SERVICE NEWS

DECEMBER, 1959

CONTENTS

Fig. 4—Push Rod Guide

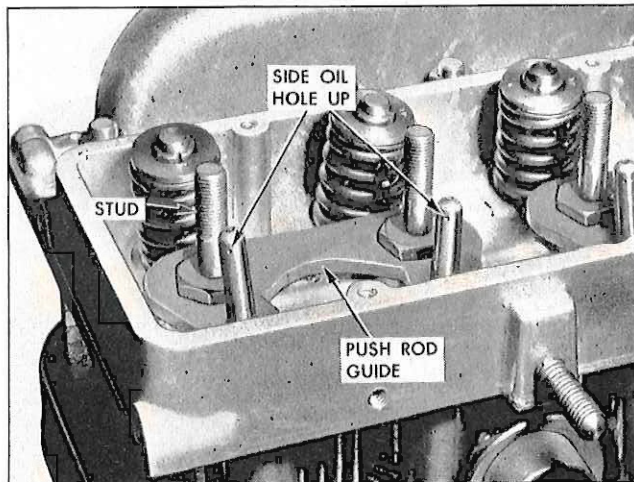
New design push rod guides are now being used in the Corvair engines. The guides improve push rod alignment and reduce valve tip wear. This is accomplished by reducing the size of and relocating the push rod guide holes.

The guides are held in place by the rocker arm ball studs (fig. 4). The new guides eliminate the need for attaching bolts and rocker arm ball stud washers. It is now necessary to remove the ball studs before removing the push rod guide. This affects service operations on replacing valve lifters or push rod tube seals.

The ball stud holes in the push rod guides are chamfered. The guides are installed with the chamfered side up. The top side is stamped with a "U" marking. Remember, the torque on all threaded attachments is important on the Corvair Turbo-Air Engine. Always use a torque wrench on the ball studs if the push rod guides must be disturbed for any reason.

Fig. 5—Neutral Safety Switch

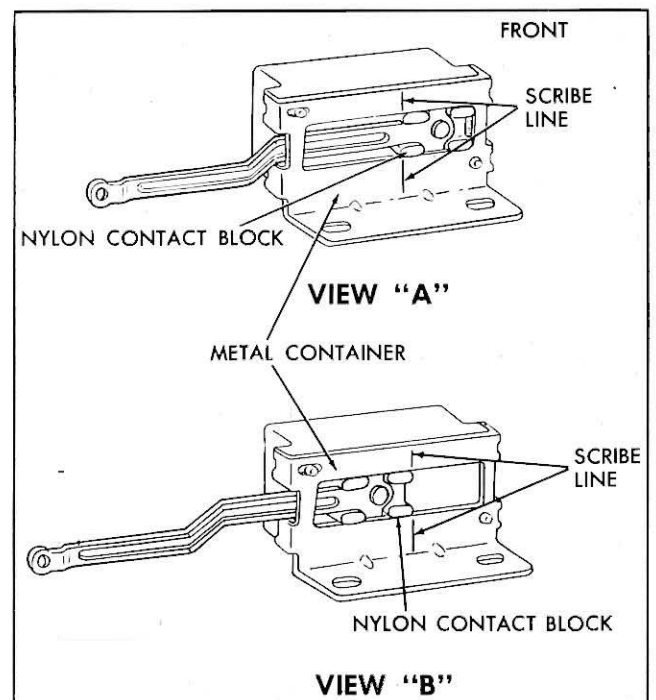
An improved procedure for adjusting the neutral safety switch has been developed. With this method it is not necessary to remove the switch to make the adjustment. This procedure supersedes the information presented in the 1960 Corvair Shop Manual.

2. Position transmission selector lever in Neutral.
3. Push nylon block, in the neutral safety switch, as far forward as possible.
4. Scribe a line on the right side of the metal container in line with the rear end of the nylon block, view A (fig. 5).

5. Pull the movable lever out (toward the rear of the vehicle) and attach the lever to the transmission range selector rod. Install the "E" washer.
6. Loosen the two neutral safety switch mounting screws. Move the metal container so the scribed line will line up with the front end of the nylon block, view B, (fig. 5).
7. Tighten the two mounting screws and sight up along the side of metal container to check for proper alignment of nylon block with scribed line.
8. Check operation of neutral safety switch. The engine must only start in "N"—Neutral position. Check operation of back-up lights (if installed).

Fig. 7—Corrected Float Position

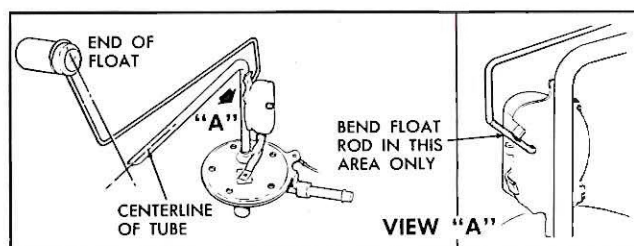
1. Drain the gas tank.
2. Remove the fuel gauge.
3. Position the float on a bench in the "up" position. NOTE: Normally the float rod is in line with the centerline of the pickup tube.
4. Bend the float arm in area "A" so the end of the float is in line with the centerline of the pickup tube (fig. 7). NOTE: When bending, the float must move parallel to the bottom of the tank. If the height of the float changes, the fuel gauge reading will be incorrect.
5. Install the fuel gauge into the tank.

Fig. 8—Vacuum Hose Connection—Powerglide

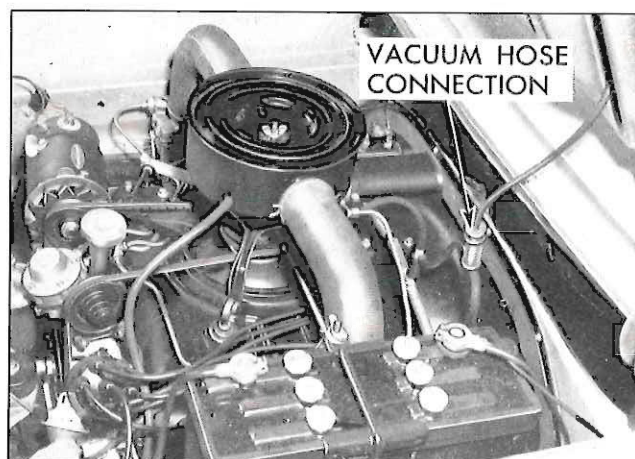
NOTE: The following supplements step 23, page 7-13, Corvair Shop Manual. With the use of a

jumper hose and tee, connect the vacuum line into the choke housing balance tube hose (fig. 8). Improper idle speed adjustment will result if the idle speed is adjusted with the choke housing hose disconnected. This procedure supersedes step 23, Tune-up Section, page 7-13, Corvair Shop Manual.

Fig. 9—Automatic Choke Adjustment

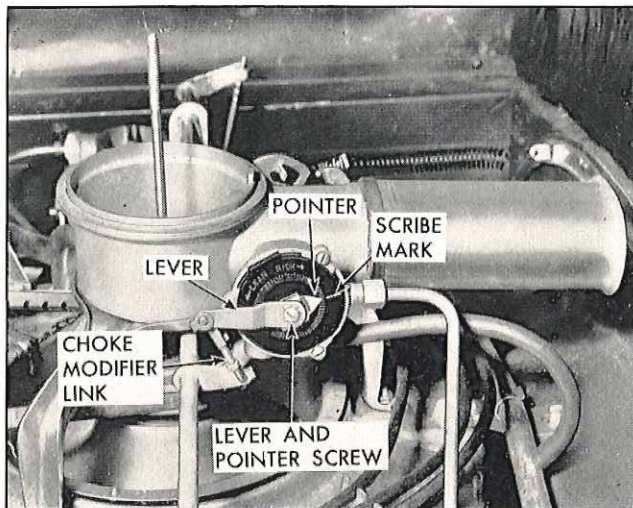
1. Choke modifier lever must be attached to crossshaft lever by means of a modifier link and the carburetors should be adjusted for the correct idle speed.
2. Loosen lever and pointer screw.
3. Allow thermostat spring to return to free position.
4. Rotate pointer clockwise to align it with the scribed line (fig. 9).
5. Tighten lever and pointer screw.

NOTE: This procedure supersedes information presented in 1960 Corvair Shop Manual.

Fig. 10—Fast Idle Adjustment

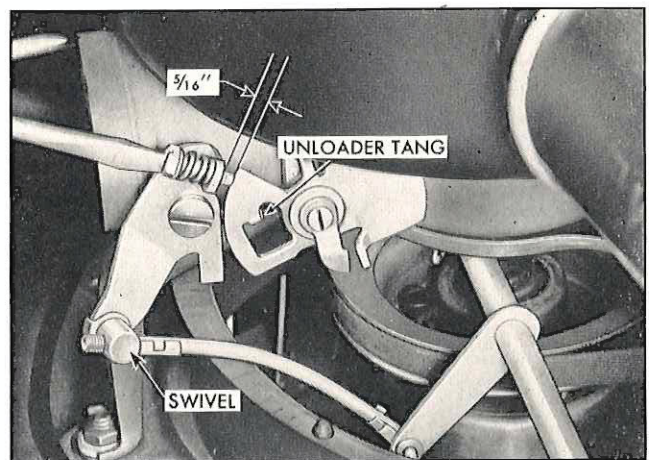
3. Place $\frac{1}{8}$ " spacer between the throttle lever and adjusting screw at the right hand carburetor.
4. Remove the clip attaching the fast idle swivel to the fast idle lever (fig. 10).
5. Turn down the fast idle adjusting screw until $\frac{5}{16}$ " of the screw projects beyond the threaded part of the lever.

NOTE: This specification supersedes information presented in 1960 Corvair Shop Manual.

6. Rotate the fast idle cam counterclockwise (viewed from left of vehicle) until the fast idle screw rests on the highest portion of the cam (fig. 10).

7. Holding the screw and lever in this position, adjust the swivel on the fast idle link until the swivel pin will just enter the hole in the fast idle lever. Clip the swivel and link in position (fig. 10).
8. Remove $\frac{1}{8}$ " spacer. Linkage clearances will

Fig. 11—Accelerator Linkage

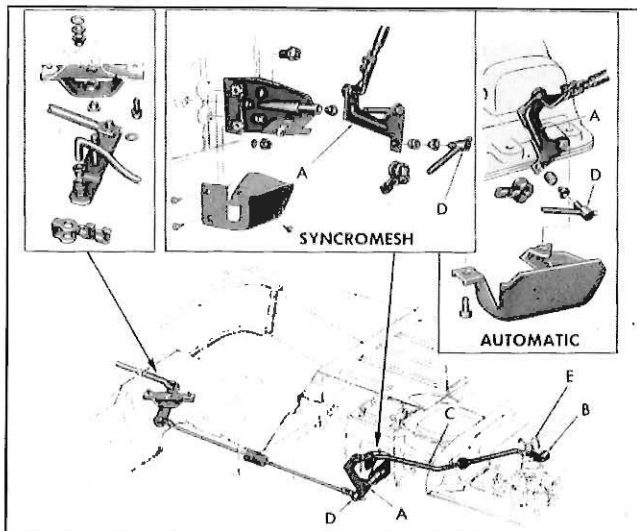
This procedure supersedes the information presented in the 1960 Corvaire Shop Manual.

1. Remove three screws attaching the mud guard over idler lever "A" and remove the mud guard.
2. Disconnect swivel "D" from lever "A" (fig. 11).
3. Disconnect swivel "B" from the left carburetor cross shaft lever "E" (fig. 11).

4. Pull rod "C" to wide open throttle (through detent for Powerglide and against the stop for standard transmission) and turn lever "E" in wide open throttle position (carburetor throttle lever against the stop). Adjust swivel "B" to align with hole in lever "E", then lengthen rod "C" by backing off swivel five full turns.
5. Position accelerator pedal by placing a block of wood between pedal end and floor pan or mat. Refer to chart for correct size wood block.
